DS-K1T680 Series MinMoe Terminal Release Note (2022-03-09)

DS-K1T680 Series MinMoe Terminal Release Note (2022-01-26)

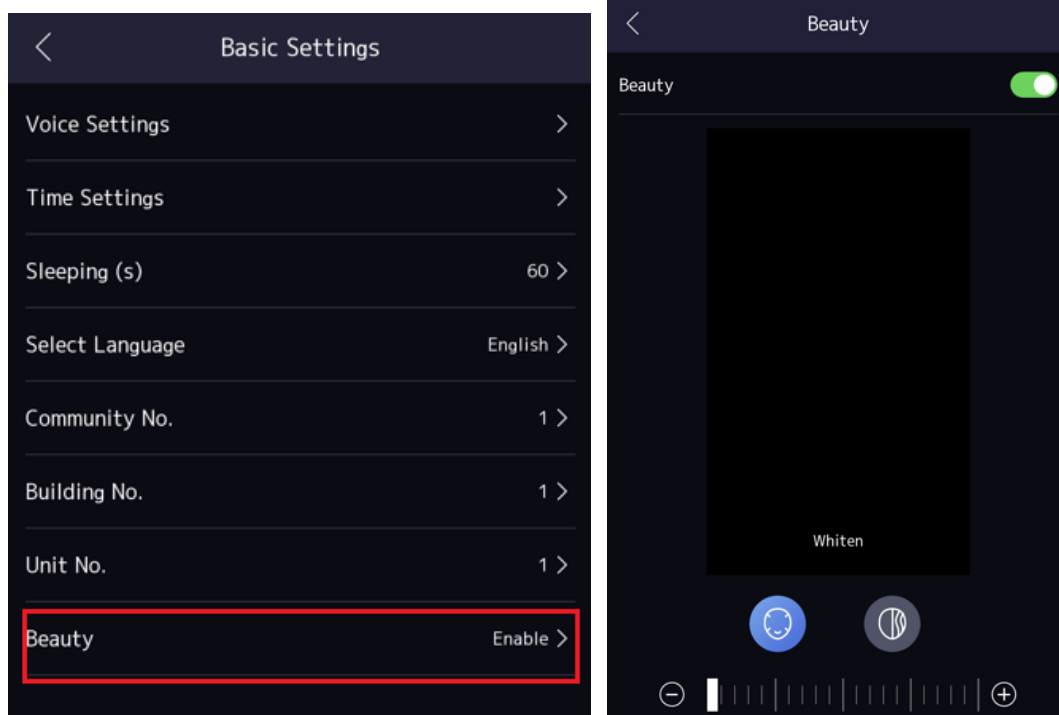
- Support **advertisement mode**: upload pictures from web and always display on the screen, recommend using company logo or advertisement picture.

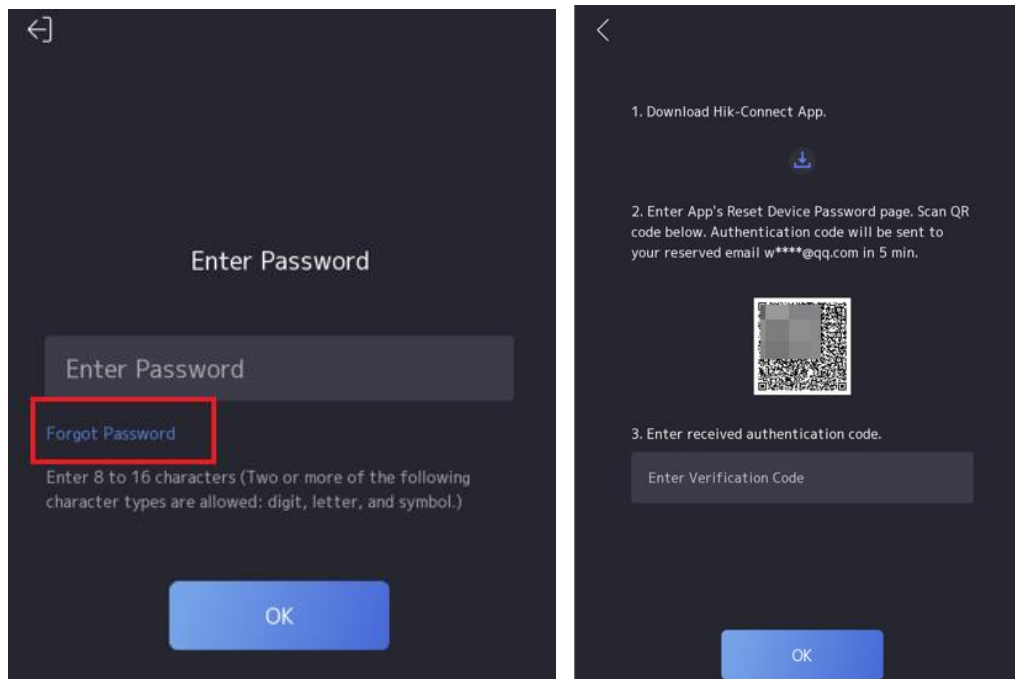
4. Support beauty function

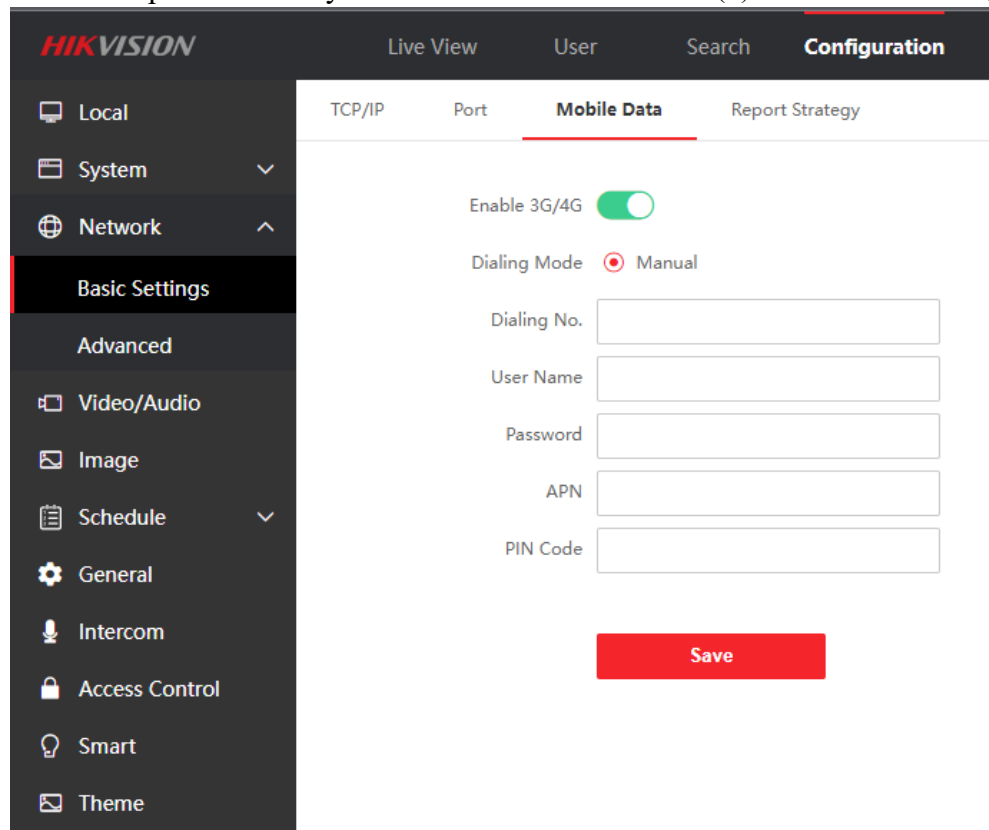
- Support APN configuration.

Note: The parameter only work for model DS-K1T680D(F)G and DS-K1T680D(F)G1

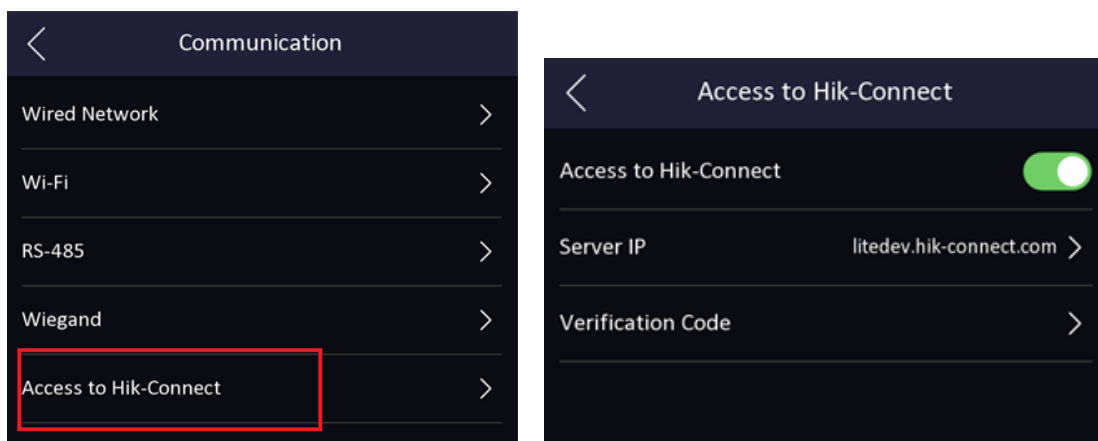
1. Add Hik-Connect menu in device UI Menu → Comm. The function is disabled in default.

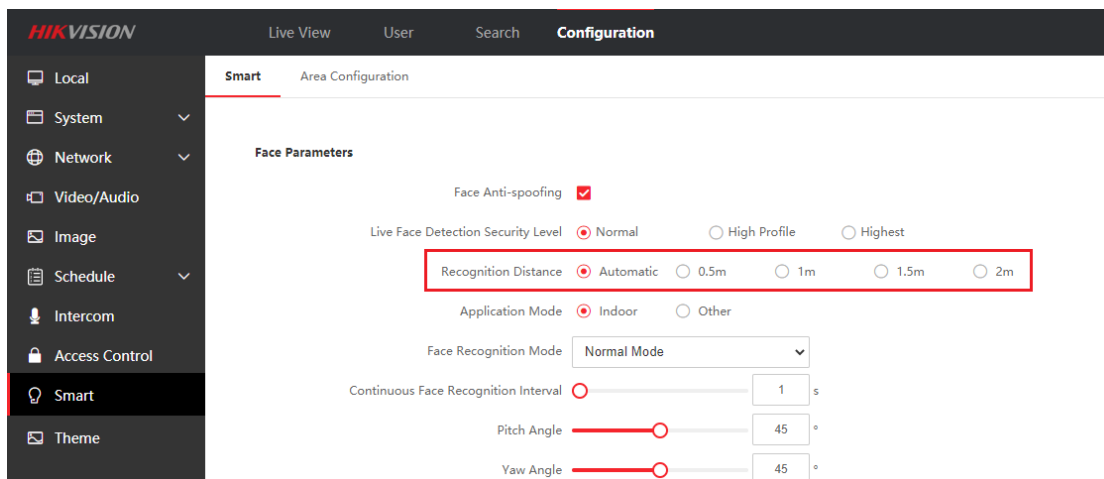
1. Optimize the wake-up distance of the device screen through the face, and the wake-up distance is consistent with the recognition distance

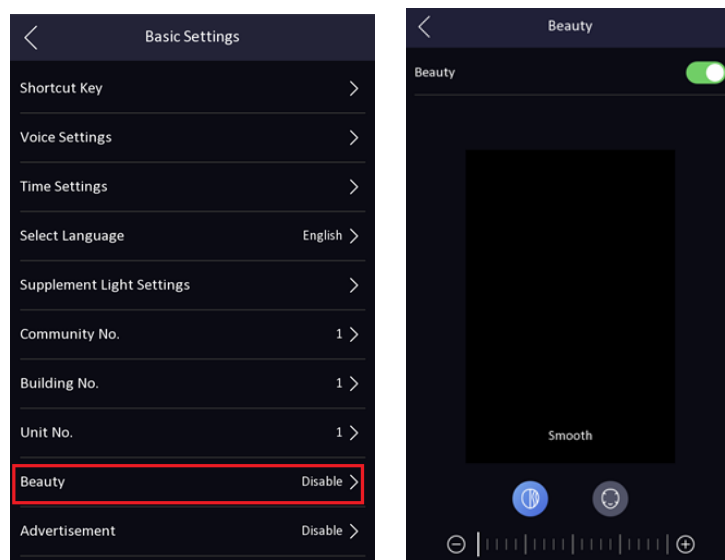
3. Add beauty function to adjust smooth and whiten parameter.

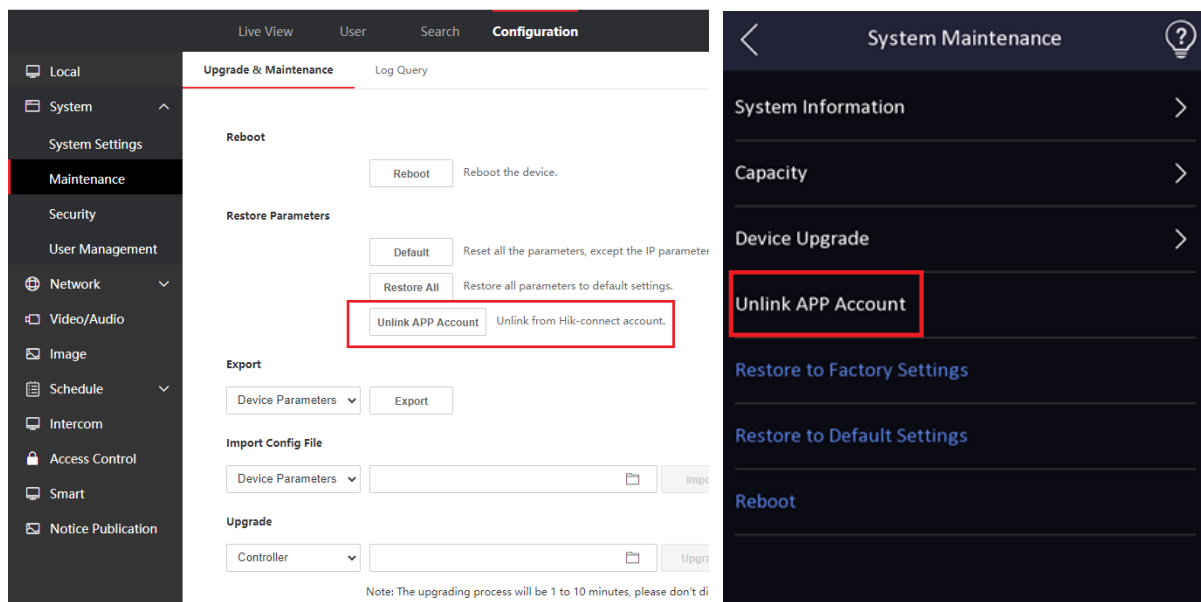
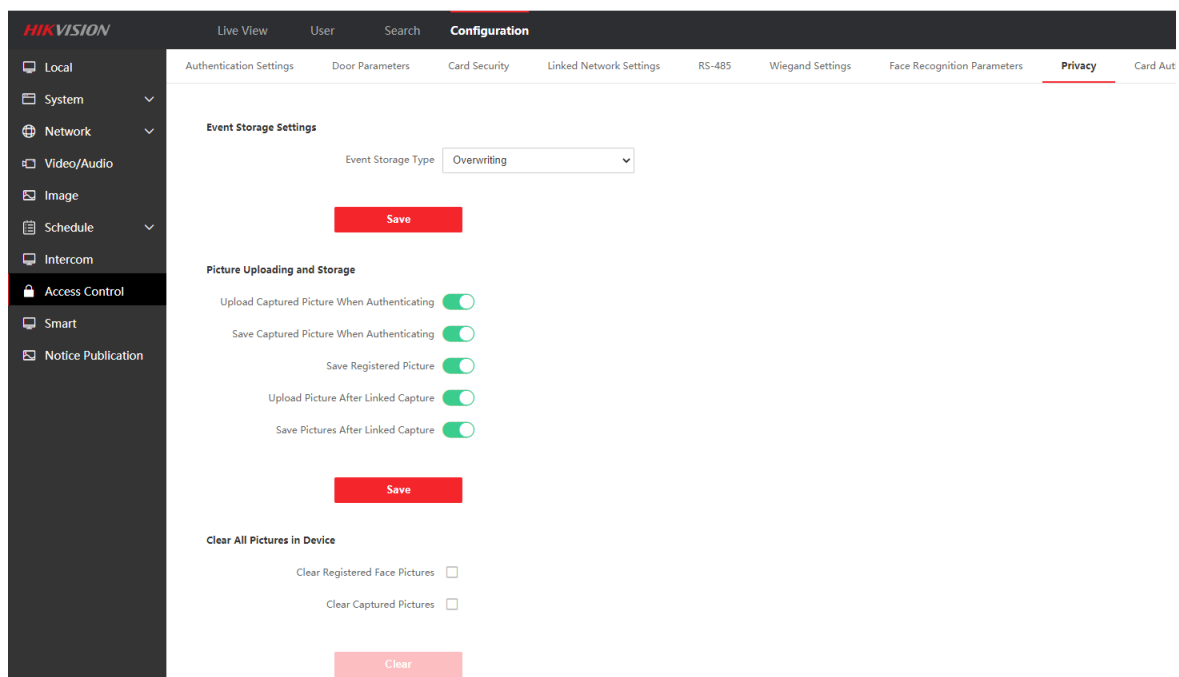
6. Support unbind device with hik-connect account on SADP tool, local UI and web

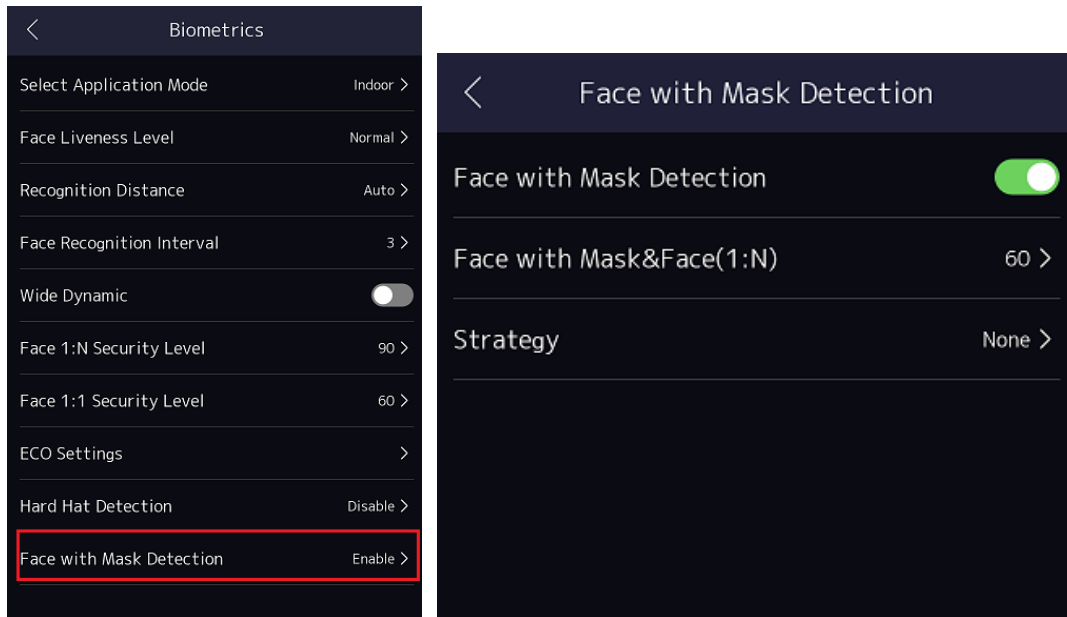
7. Add privacy protection, support event Storage Settings, Picture Uploading and Storage, Clear All Pictures in Device

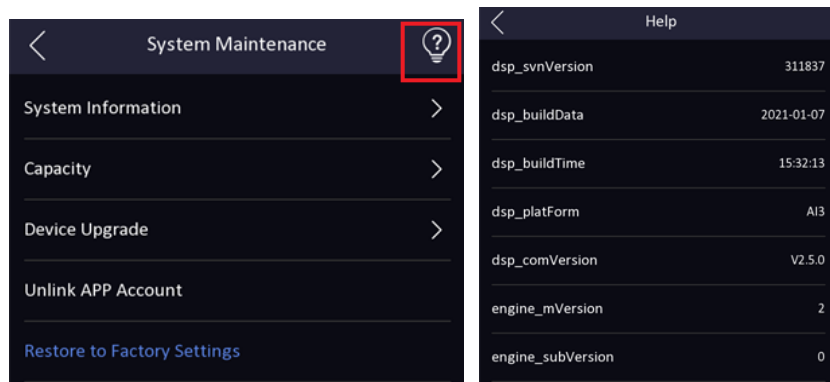
8. Add face mask detection function(enabled in default);

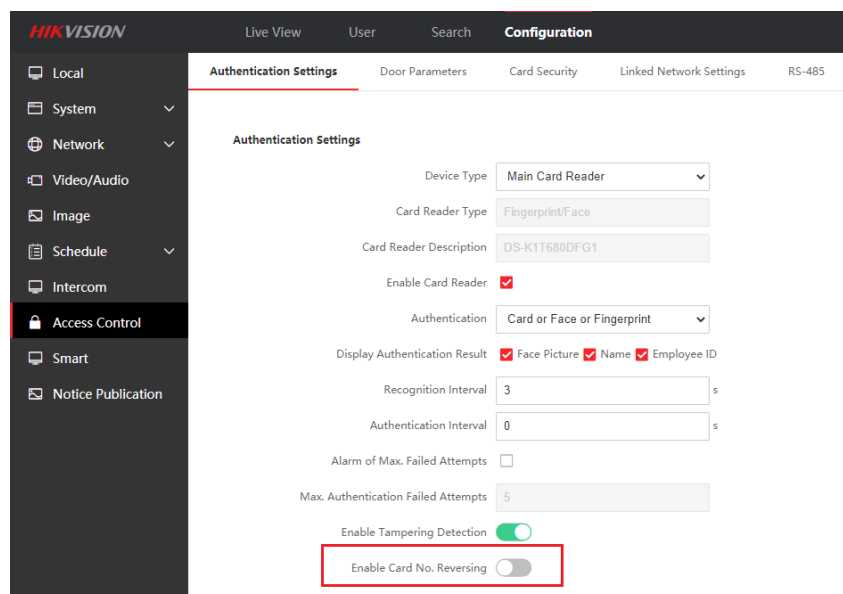
9. Add help interface to check system module version for technical support (long press for 3s).

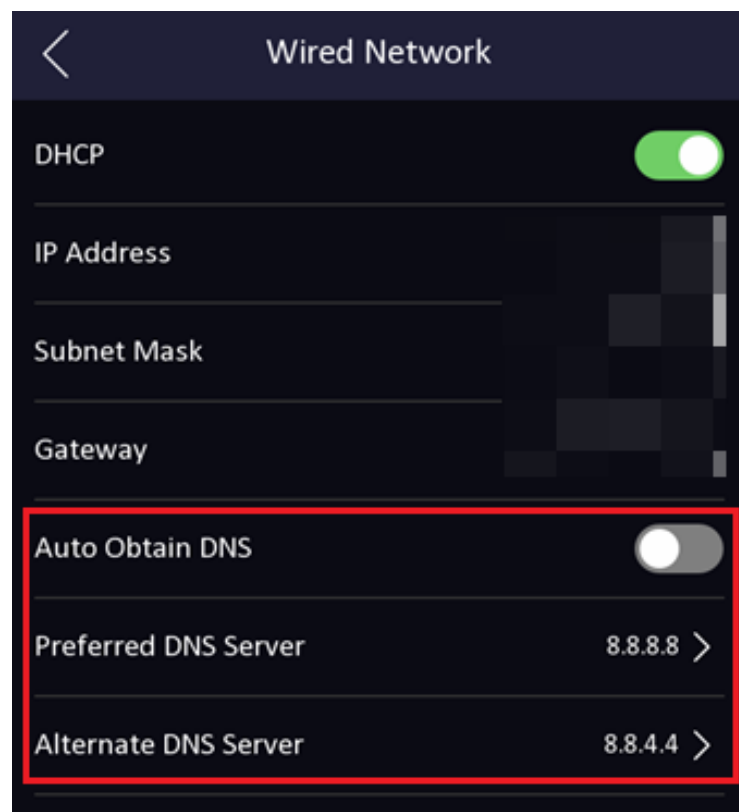
- Hik-Connect function is turned off in default for privacy protection, if customer want to manage device from App, please turn on manually in the web.

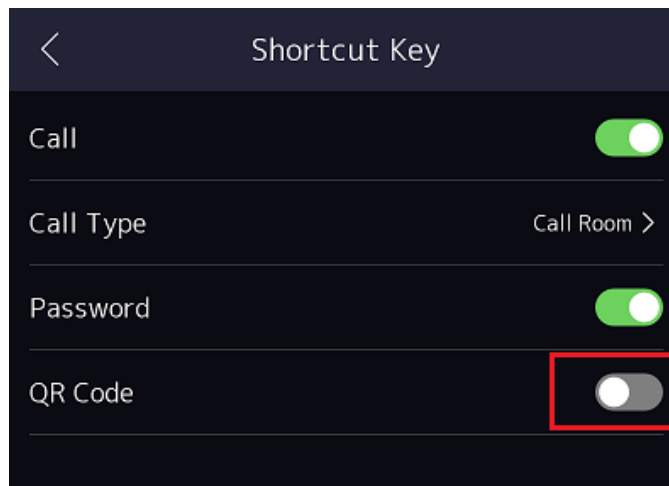
- DNS can be configured from device UI in menu → Comm.-->Wired Network

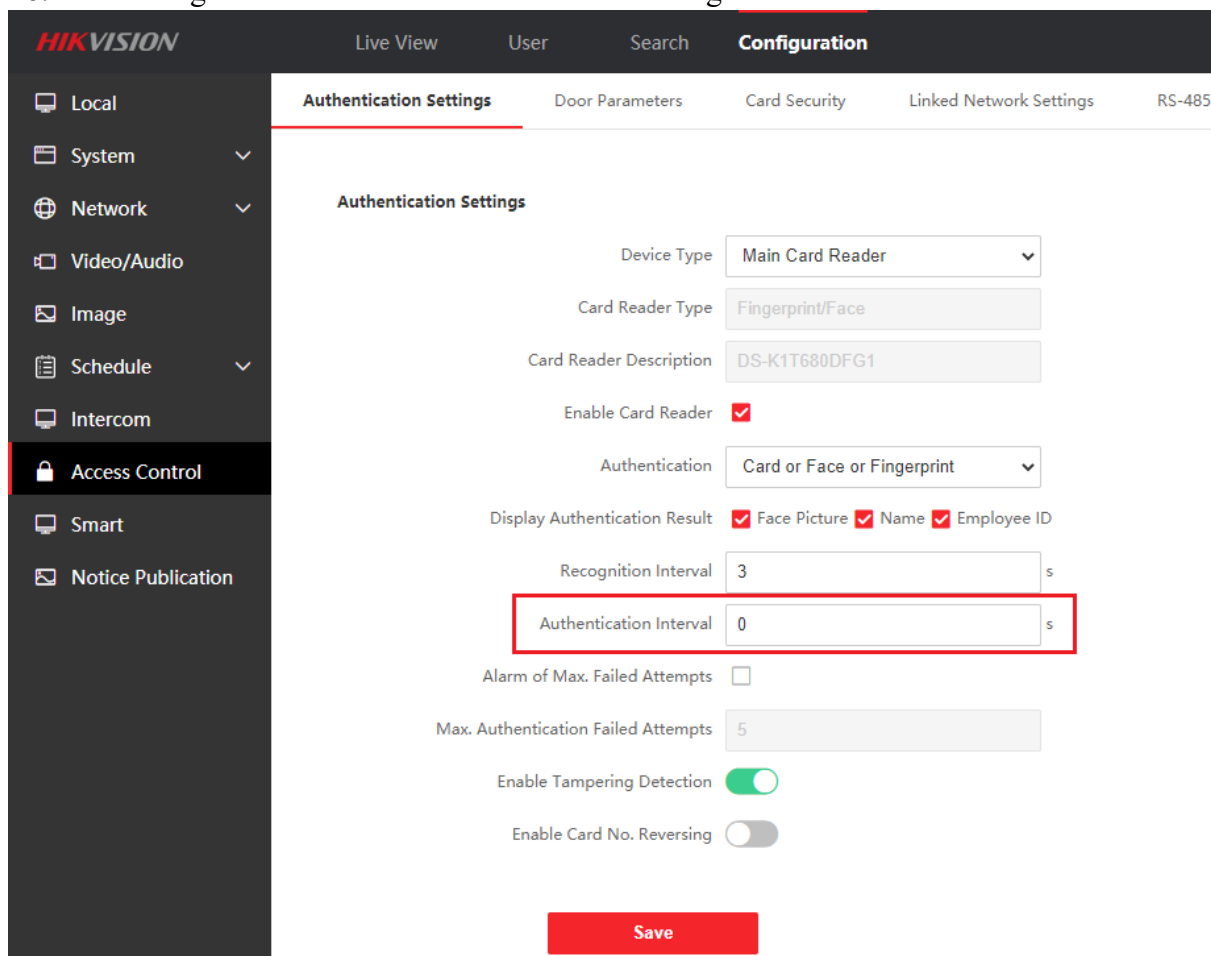
- After disable QR code shortcut from the menu, device will support QR code and face verification at the same time.
